SERVICE BULLETIN

No. 250A

Piper Aircraft Corporation

Subject: Installation of Right Fuel Tank Quantity Gauge Placard

PLACARD ATTACHMENT

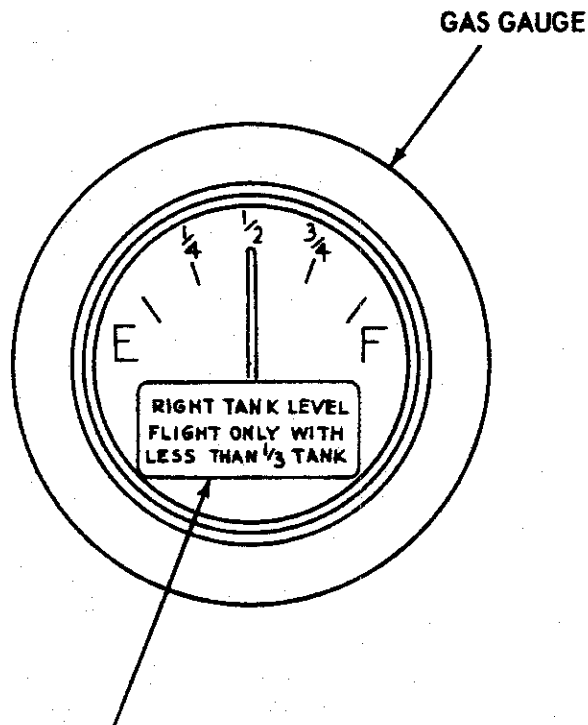
Reason for Supersedure: Revised Right Fuel Tank Quantity Gauge Placard.

Purpose: To provide a revised right fuel tank quantity gauge placard for the above referenced aircraft (see sketch on reverse side of this bulletin for a pictorial description).

Aircraft equipped with either a single or dual fuel quantity gauge installation must have the placard installed and the operator must comply with its contents when a right fuel tank is selected.

1. REMOVE EXISTING PLACARD.
2. APPLY NEW PLACARD P N 15306-00 AS ILLUSTRATED.
